TITLE: Environmental Restoration  
Disposal Facility (ERDF)  
Cells 7-10 Detailed Design  
Package, Rev. 0

CONSTRUCTION QUALITY ASSURANCE PLAN (CQAP)

FOR  
ENVIRONMENTAL RESTORATION DISPOSAL FACILITY (ERDF)  
CELLS 7 THROUGH 10

# REVIEW COMMENT RECORD

**FIGURE 1. ERDF CONSTRUCTION/QUALITY ASSURANCE ORGANIZATION**

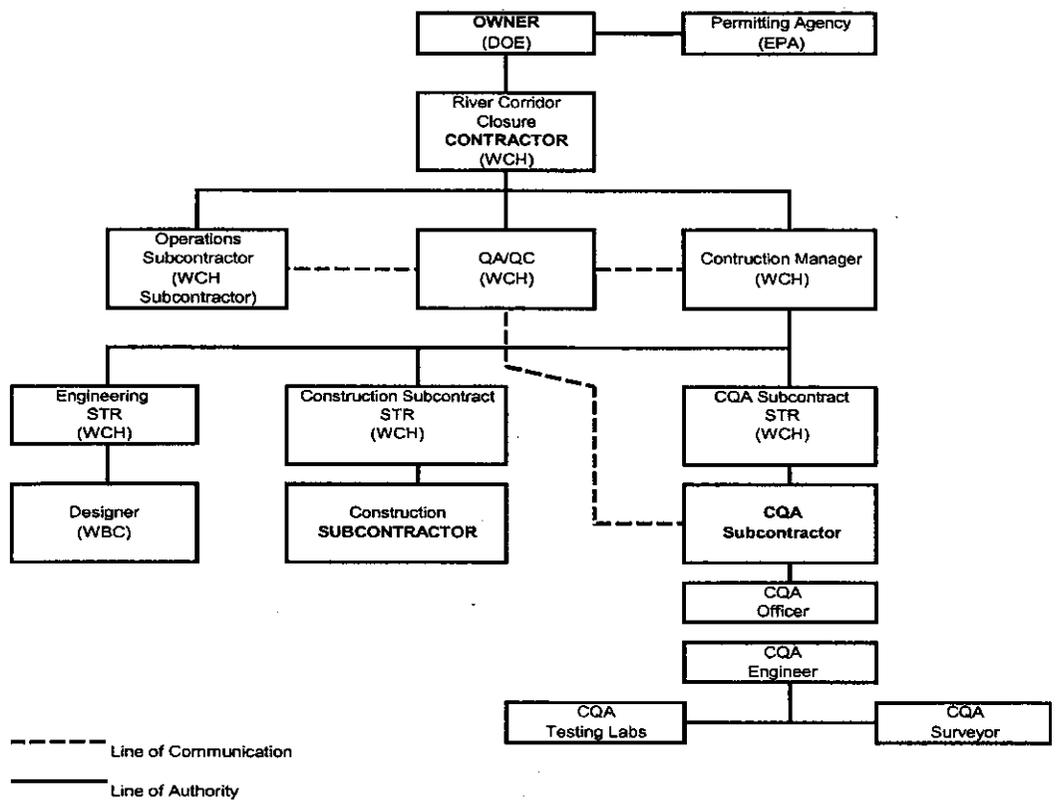
- Page 53 of 0600X-QA-G0004, Figure 1 (this related to the addition of "CQA Officer" in the project's chain of authority/communication figure).
  - Page 55 of 0600X-QA-G0004, Table 4-1 (this related to English/metric conversions).

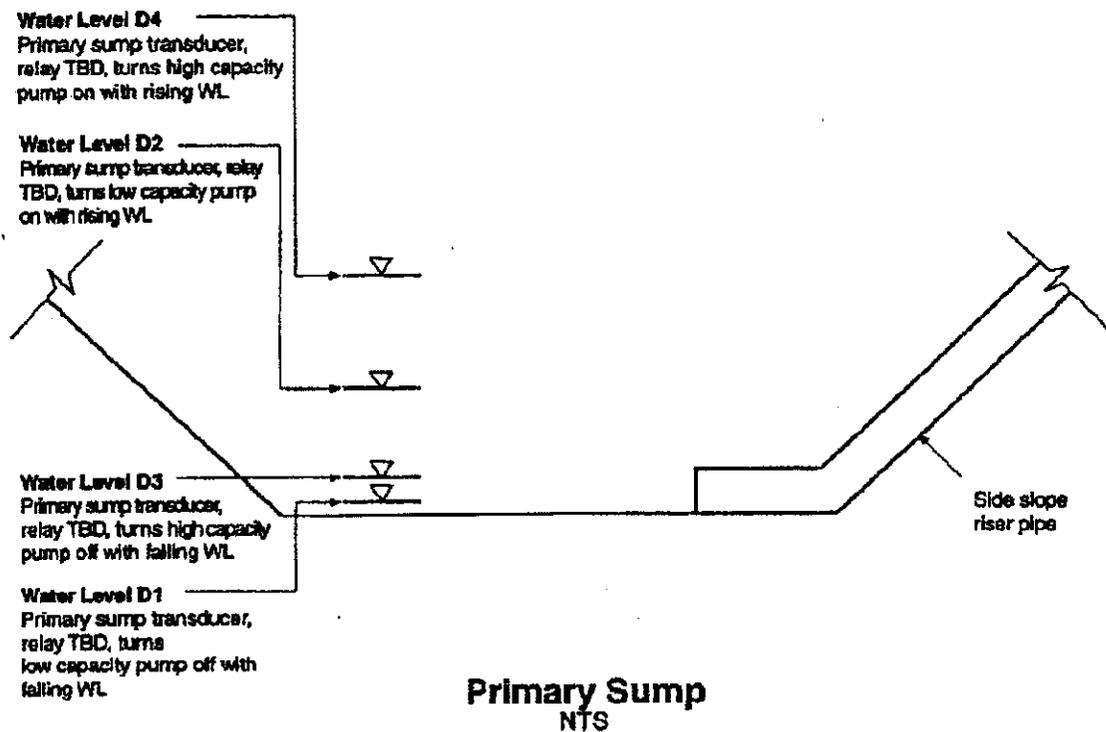
- B.1 Check line number references on schematic ladders (0600X-DD-E0118)
- B.2 Callout for note 3 on ladder line Nos. 31 and 34 should match the callout shown under NOTES (0600X-DD-E0118)
- B.3 Add nameplate call out no. (12) for data logger on the Trench Control Panel (0600X-DD-E0119)
- B.4 Add name plate no. 13 to the NAMEPLATE SCHEDULE (0600X-DD-E0119)

- A.2 Low Flow or Loss of Flow shall trigger illumination of an alarm light and shall shut off the pump. Drawing 0600X-DD-E0118 will be revised to include this control.

- A.3 The "Current Alarm" callout describes the electronic instrument used compare the current delivered by the transducers and then set the points to start and stop the pumps. Cells 1&2 use current meters. Cells 3&4 and 5&6 use an analog input module connected to a PLC to compare the current delivered by the transducers. The PLC is used to program the start and stop points for the pumps. Drawing 0600X-DD-E0118 will be revised to remove the current alarm callout.
